Re: Railway (Metrolink - Estuary to Charlemont via Dublin Airport) Order [2022]
Metrolink. Estuary through Swords, Dublin Airport, Ballymun, Glasnevin and City Centre to
Charlemont, Co. Dublin

RAILWAY (METROLINK-ESTUARY TO CHARLEMONT VIA DUBLIN AIRPORT)
ORDER 2022

RE: SUBMISSION ON THE METROLINK RAILWAY ORDER APPLICATION IN
RELATION TO THE SITE OF A COMMERCIAL DEVELOPMENT AT 2 GRAND
PARADE, RANELAGH, DUBLIN 6.

RAILWAY ORDER
Charlemont Station Observation

Fig 06A Extract from submission drawing ML1-JAI-ARD-ROUT_XX-DR-Y-02090

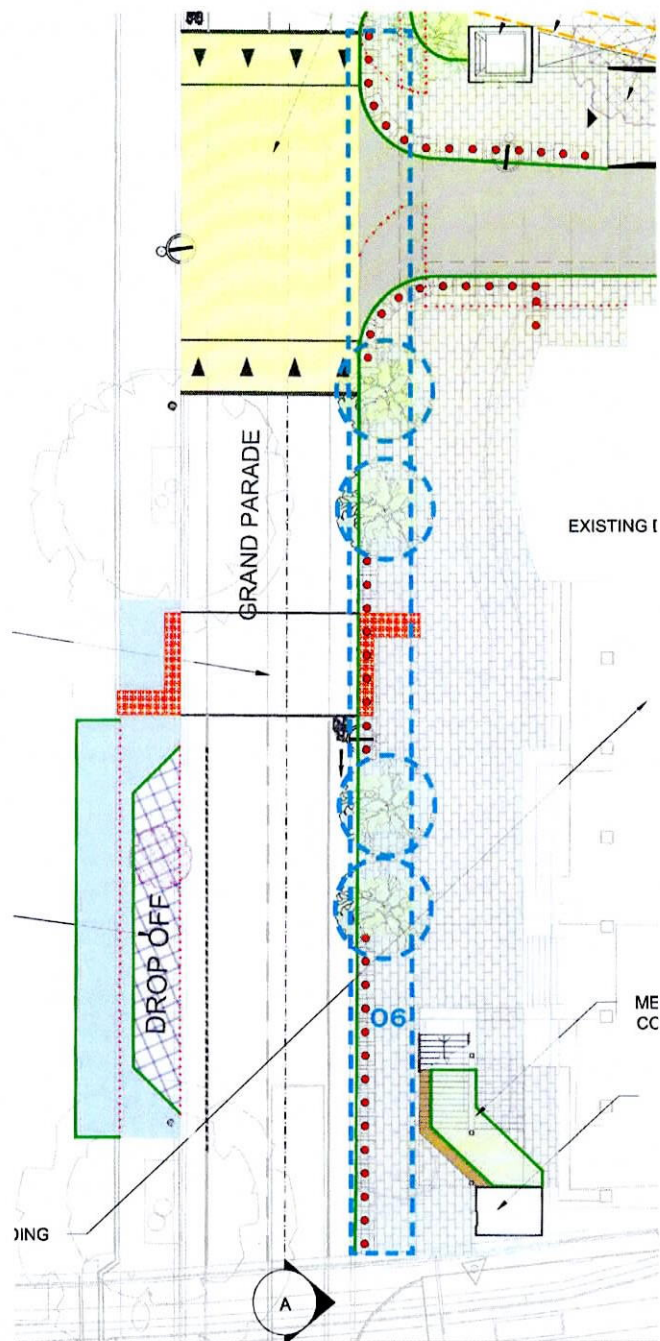
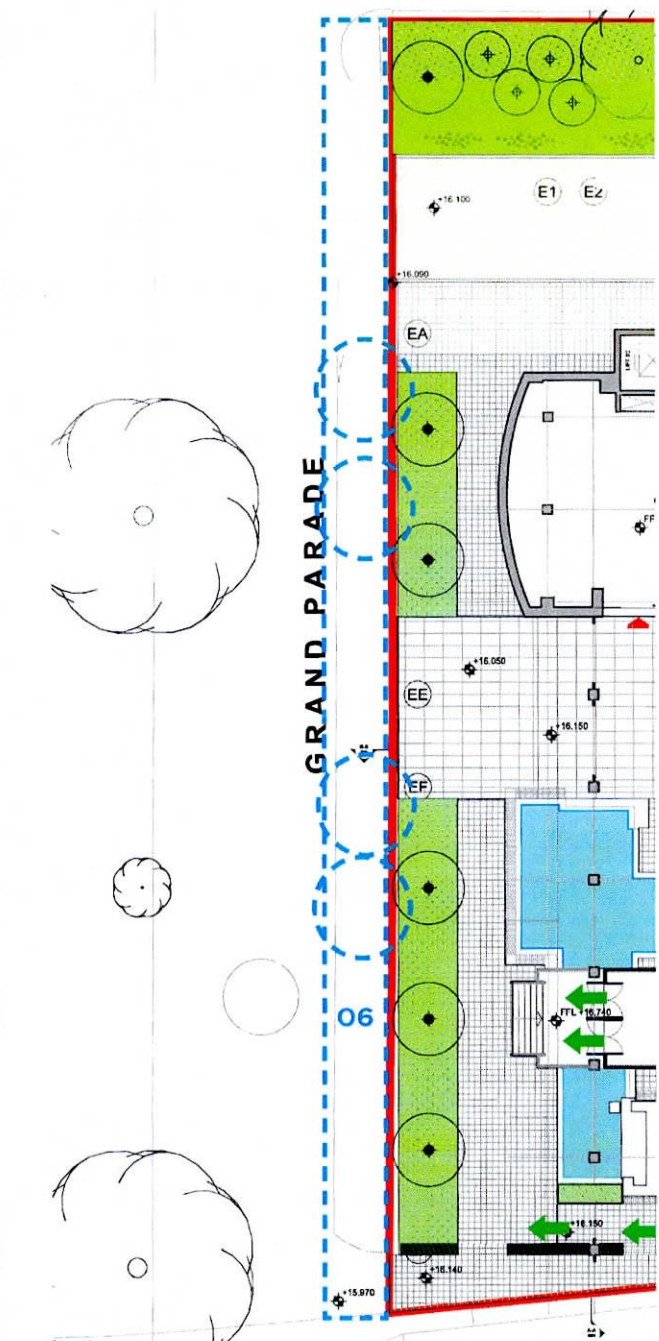
The proposed hard and soft landscaping within the public realm that interface with the 2 Grand Parade (2GP) development will need further consideration to ensure co-ordination between the tree planting and interfaces with the paving finishes and levels and entrance locations to the permitted and under construction 2GP development.

Fig 06A Extract from submission drawing ML1-JAI-ARD-ROUT_XX-DR-Y-02090

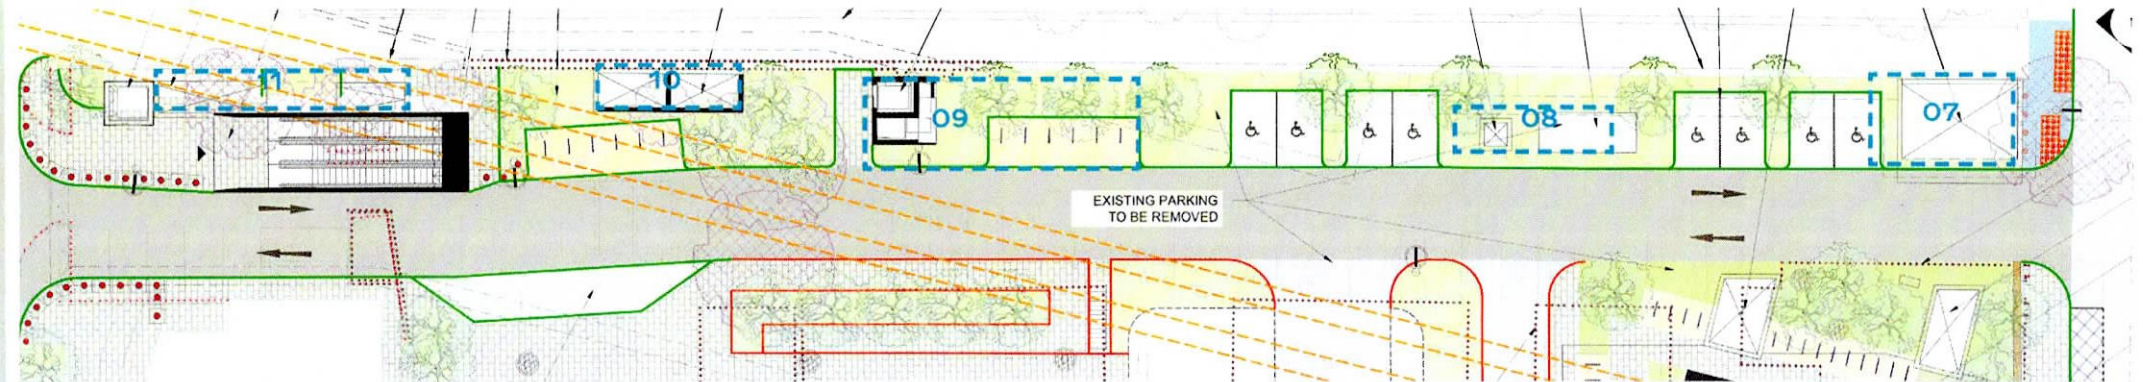
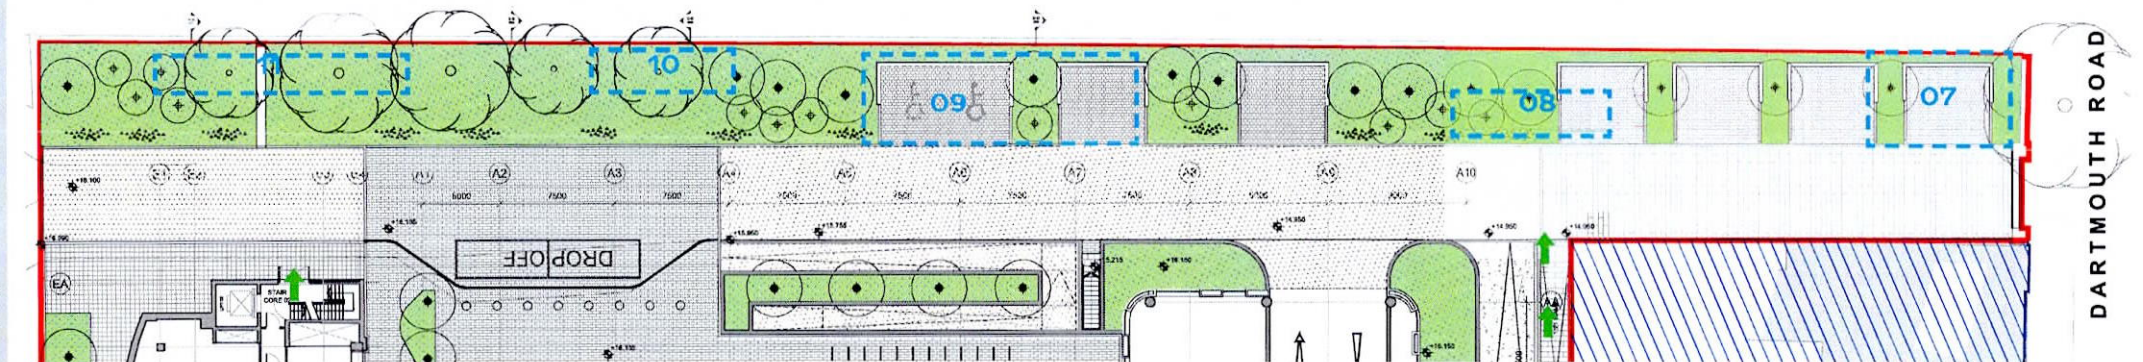
Further design information is sought on the proposed vents, lift shafts and pumping room, with detail to include heights and proposed finishes in order to demonstrate the potential visual impact to the adjacent 2GP development.

Carparking bays, as per the permitted planning, are located in this location. An alternative location for the proposed vents should be considered.

Carparking bays, as per the permitted planning, are located in this location. An alternative location should be considered. Further detail and consideration in these respects should be furnished and included on the application file prior to the granting of any railway order.

Figure 2: Extract from drawing ML1-JAI-SRD-ROUT_XX-DR-02090

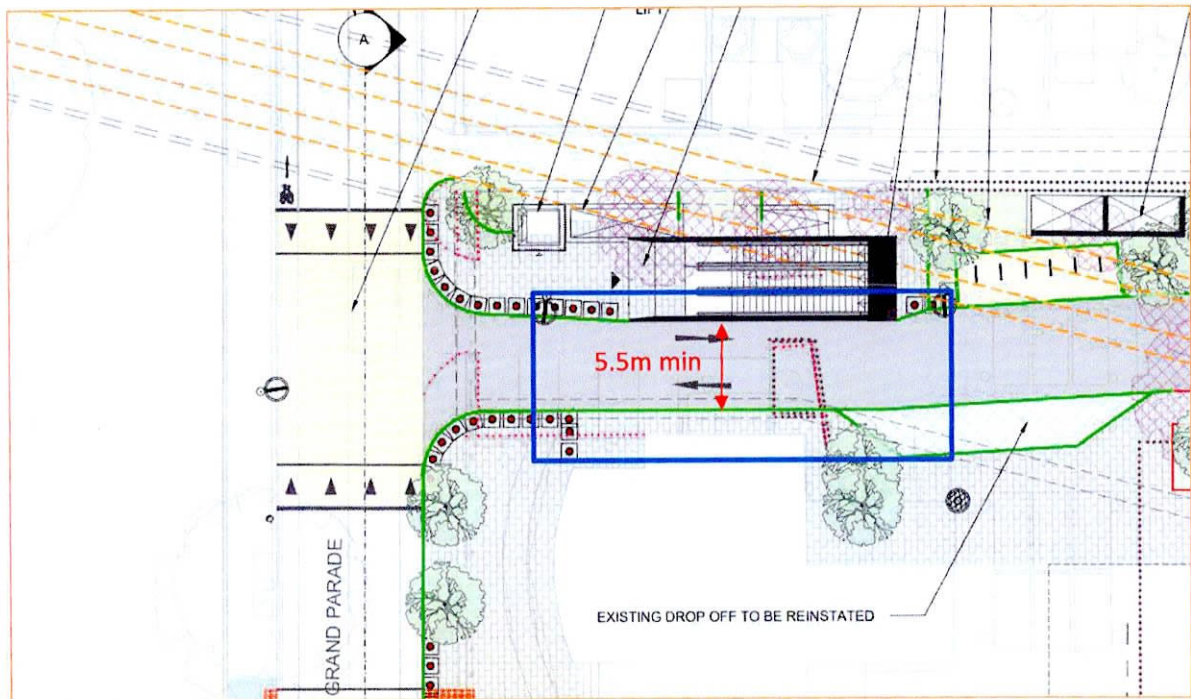
Refer to HJL observation number 1 'Grand Parade Entrance Escalators' regarding the alterations to the access to the commercial development from Grand Parade. The size and location of the escalators is such that alterations to the access road are proposed to accommodate them. It is noted that as part of the permitted scheme for 2 Grand Parade a 6m wide access road is required to allow access for 2 vehicles to pass each other. This road is proposed as 4m wide following the completion of the Metrolink development (refer to figure 3) which is insufficient for 2-way traffic. The minimum width considered acceptable is 5.5m clear from inside face of kerbs. The Railway Order drawings and documents should be revised to reflect this width.

A raised traffic table is proposed at the entrance to the property from Grand Parade as shown on figure 2. This alteration will result in changes to the access road levels and permitted drainage strategy and as such further information is required to assess the implications of this aspect of the design.

Figure 8: Extract from A5.3 'Construction Sequence report' pg 152

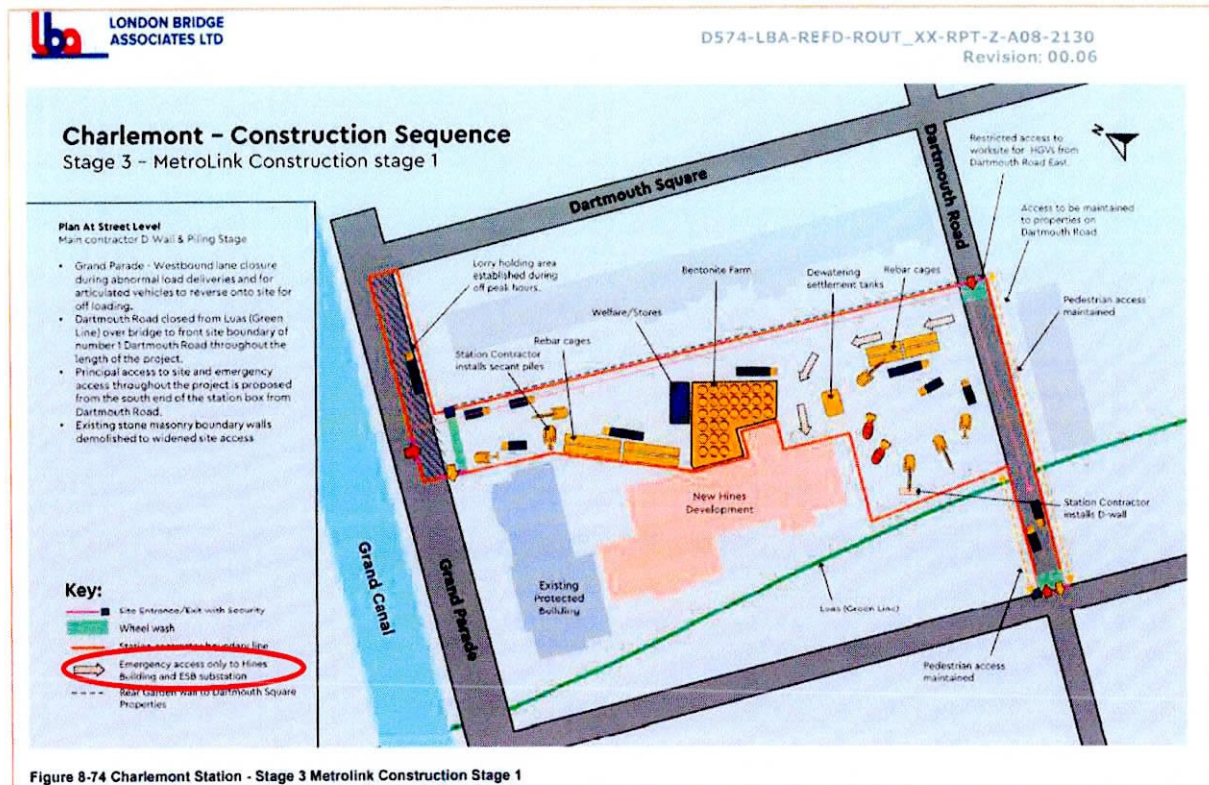
There are 2 proposals outlined for Charlemont station from page 150-165 in Appendix A5.3 'Construction Sequence Report' within the EIAR. The first option entitled *'Charlemont – Construction Sequence'* describes a methodology that does not allow for any access (other than emergency) to the basement of 2 Grand Parade during the construction period and is considered unacceptable by our client (refer to example in figure 8).

Note that our client will require 24 hour unimpeded access for vehicles and cyclists to the basement, plant areas and ESB substation.

Figure 9: Extract from A5.3 'Construction Sequence report' pg 158, EIAR

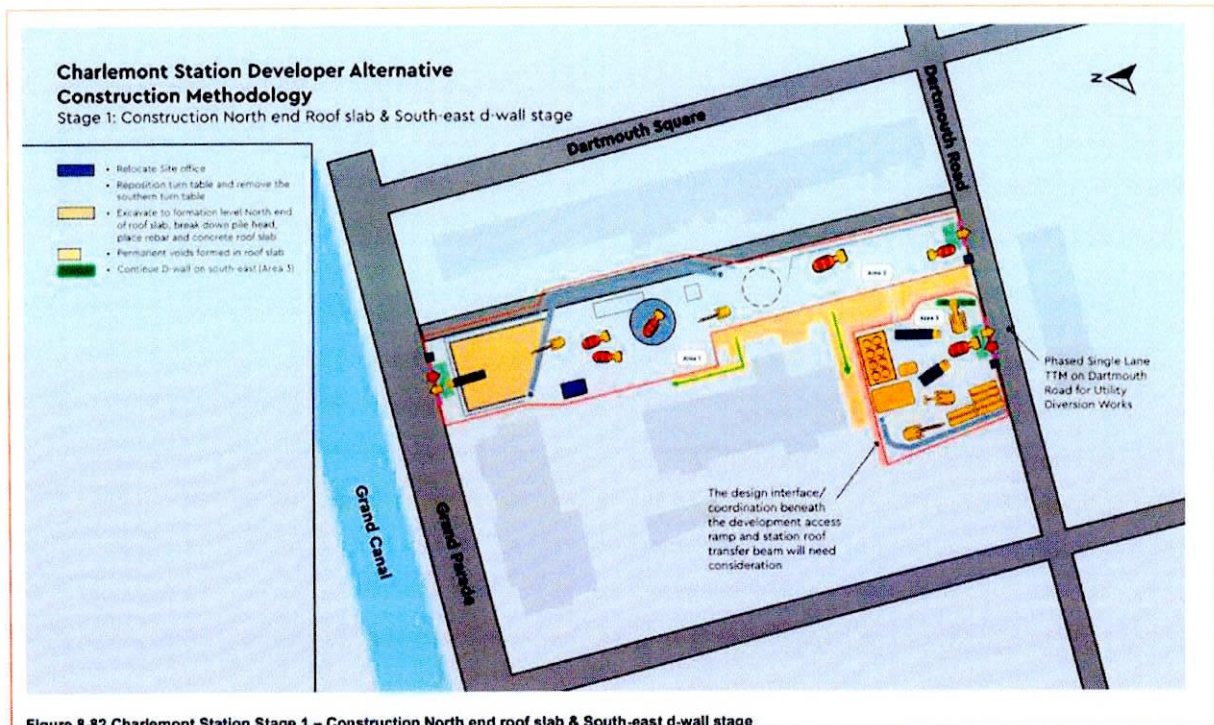
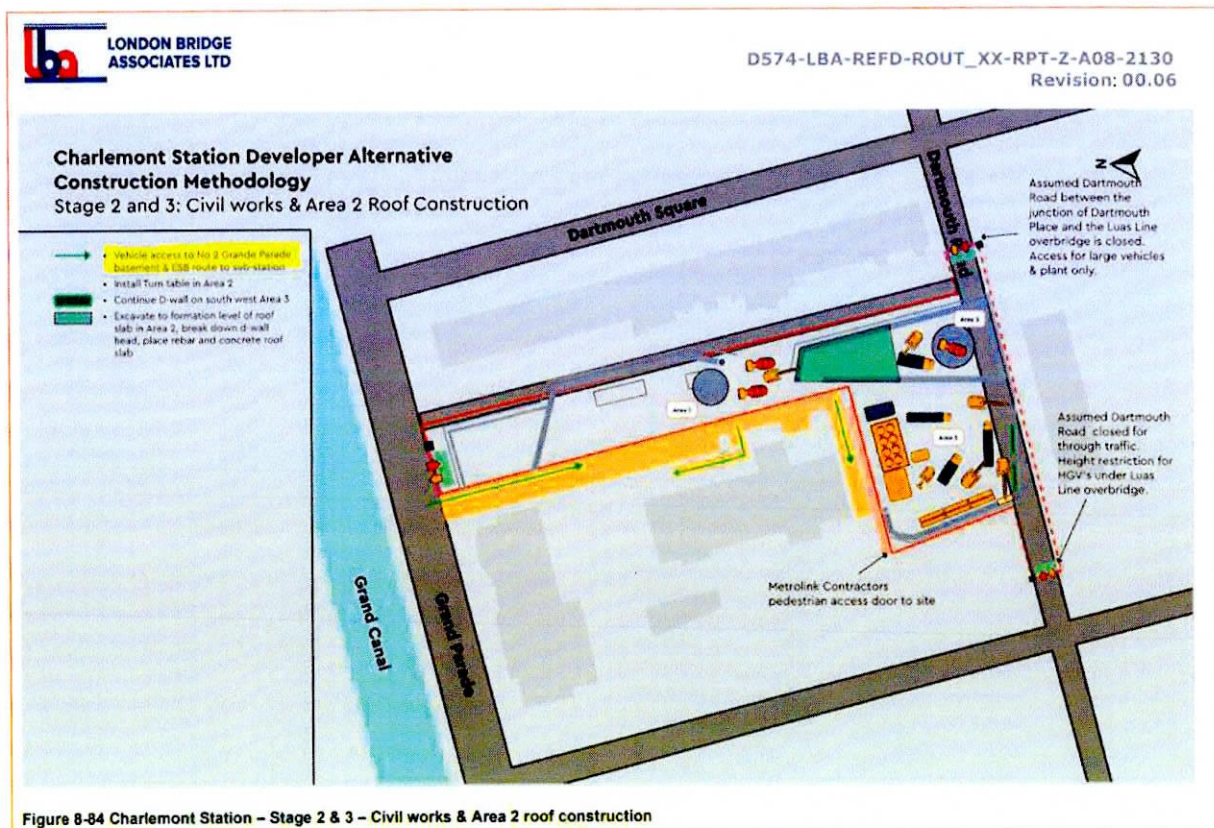
The second option entitled '*Charlemont Station Developer Alternative Construction Methodology*' allows for access to the basement of 2 Grand Parade for the full duration and is the only option that is considered potentially acceptable to our Client (refer to example in Figure 9). The Construction Programme, contained in Appendix A5.2 of EIAR, indicates that the duration of construction of the station is 8.5 years and our Client has serious concerns over this. The construction sequence provides a very limited amount of information in relation to the various elements of the works. This needs to be expanded to break the sequence down into smaller more detailed segments and include timeframe for each of these elements so that a proper assessment of the impact on the 2 Grand Parade building during the construction phase can be made.

- 24 hours safe access to the basement car park.
- 24 hours safe access to bicycle parking.
- 24 hours safe access to ESB substation.
- 24 hours safe access for Emergency Vehicles
- All site services to be kept live at all times

Figure 11: Extract from A5.3, EIAR 'Construction Sequence report' pg 158

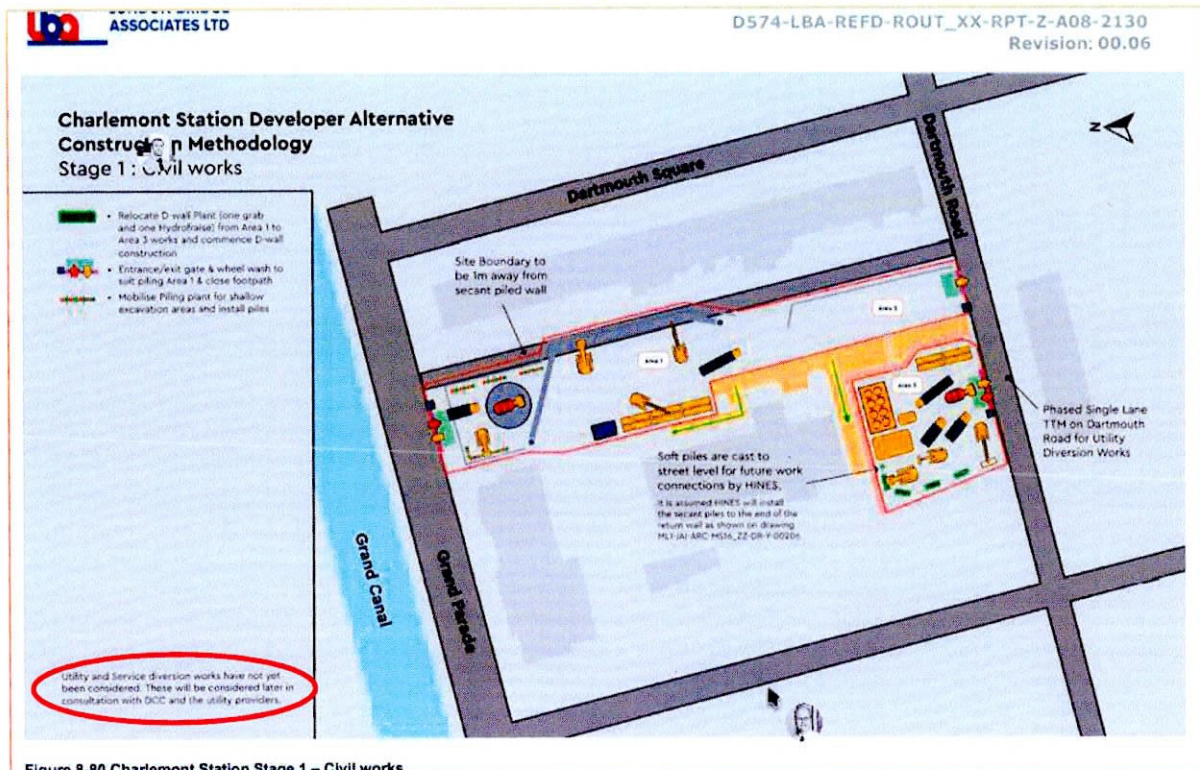
All services to the 2 Grand Parade building are to remain live for the entire duration of the construction works. Further information is required to confirm how this will be achieved. The construction methodology drawings note that service diversions are to be agreed with DCC and utility providers but not necessarily with the building owners (refer to figure 11) further information should be provided in this respect prior to the approval of any Railway Order.

Fig 01A Extract from submission drawing ML1-JAI-ARD-ROUT_XK-DR-Y-02090

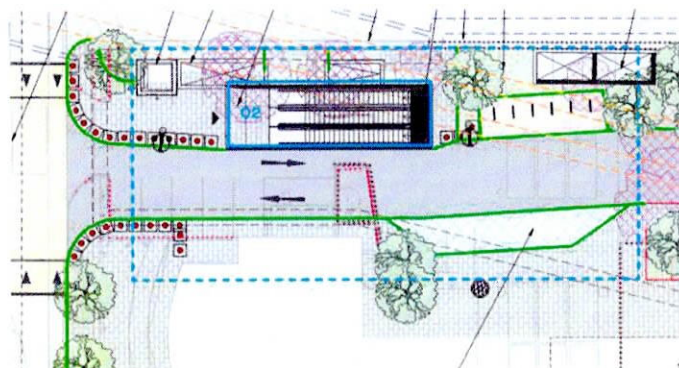
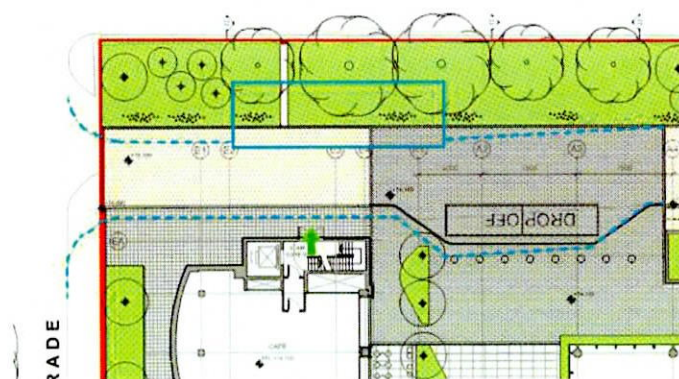
1. The Railway Order drawings do not appear to have taken cognisance of the following items.
 - a. *The proposed reduction in roadway width to the East of the 2 Grand Parade building and the adverse effect this has on escape from the building via core 2, and fire service vehicle access along the east Elevation of the building.*
